Subject: Duke Energy Carolinas, LLC
William States Lee III Nuclear Station - Docket Nos. 52-018 and 52-019
AP1000 Combined License Application for the
William States Lee III Nuclear Station Units 1 and 2
Response to Request for Additional Information
(RAI No. 2686)
Ltr# WLG2009.11-05

Lee Nuclear Station Response to Request for Additional Information (RAI)

RAI Letter No. 073

NRC Technical Review Branch: Hydrology

FIGURE 1

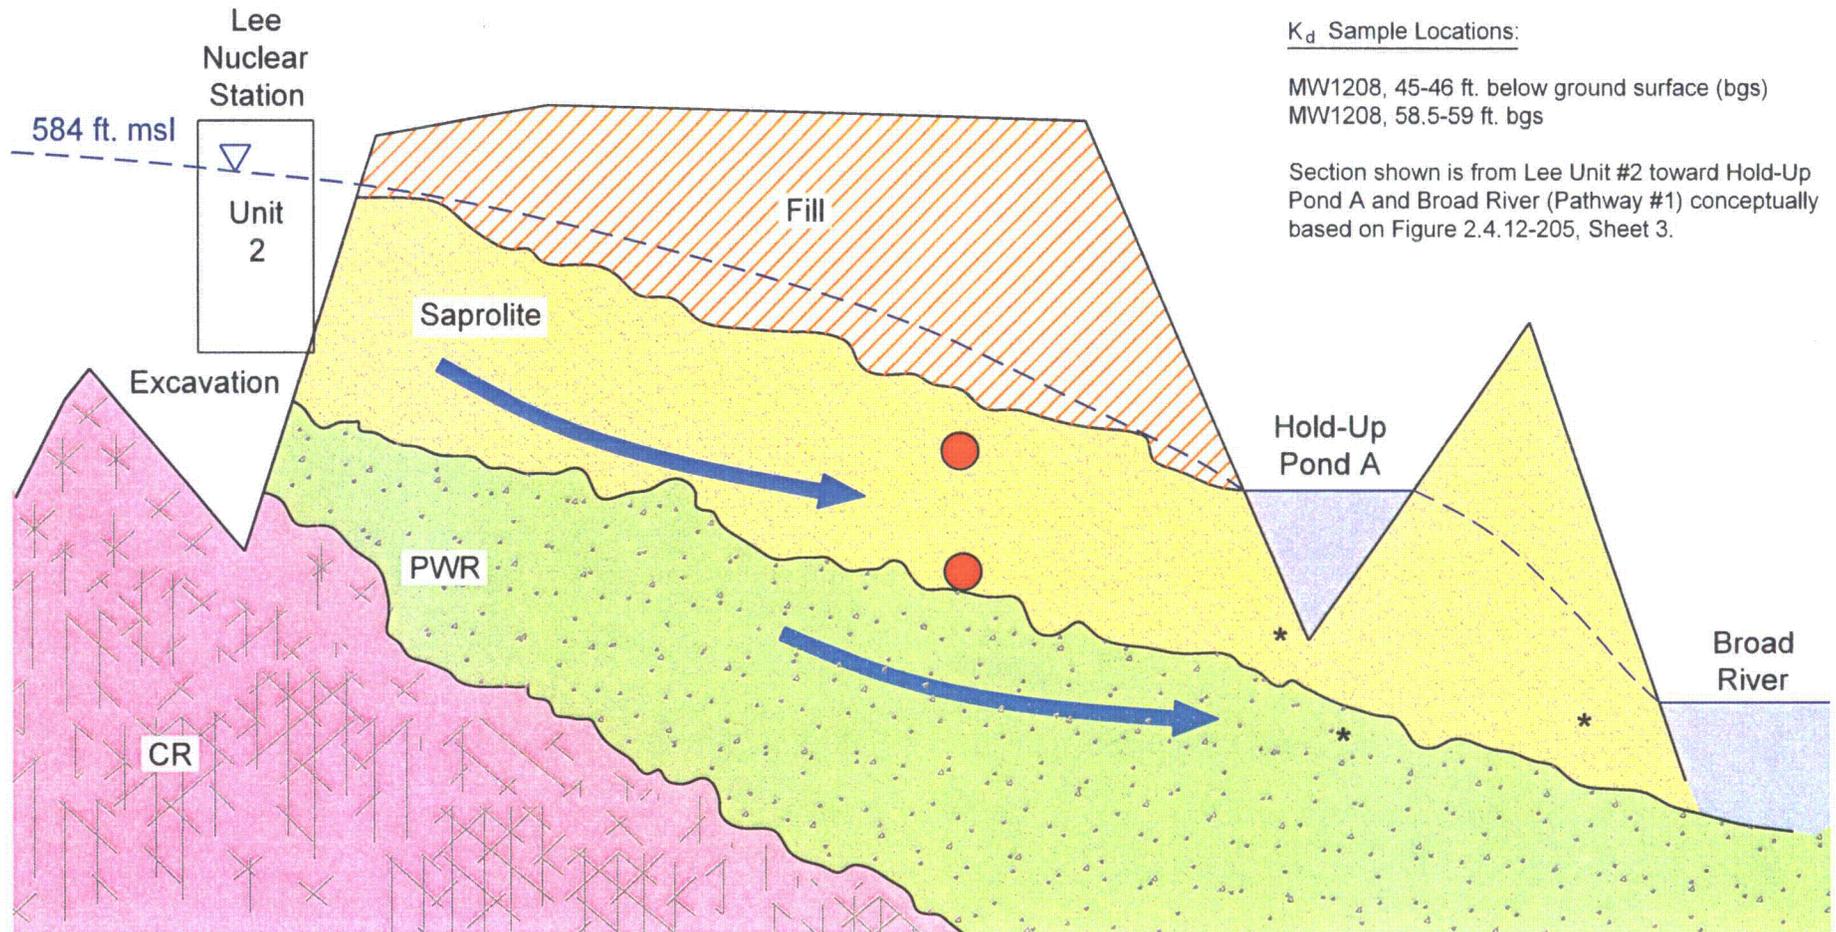
In its review of FSAR Section 2.4.13, the staff noted that there were no measurements of K_d for the PWR material, which is the material considered in the most conservative pathway. Because K_d values are important to the transport of retarded contaminants, the applicant should use K_d values for the PWR material that are measured on site samples or justify why the existing values are conservative.

Associated with this re-examination of boring logs, the general elevation of the saprolite-PWR interface in the immediate area of the Unit 2 to Hold-Up Pond A flow path was reassessed and is now interpreted to be at a higher elevation. The conceptual model of site aquifer conditions and lithostratigraphy (Figure 1, Attachment 1 to this response) reflects the results of that reassessment. This figure also depicts the locations of the two geo-media samples collected from

MW-1208 for site-specific K_d analysis. FSAR Figure 2.4.12-205 will be updated in a future revision of the FSAR.
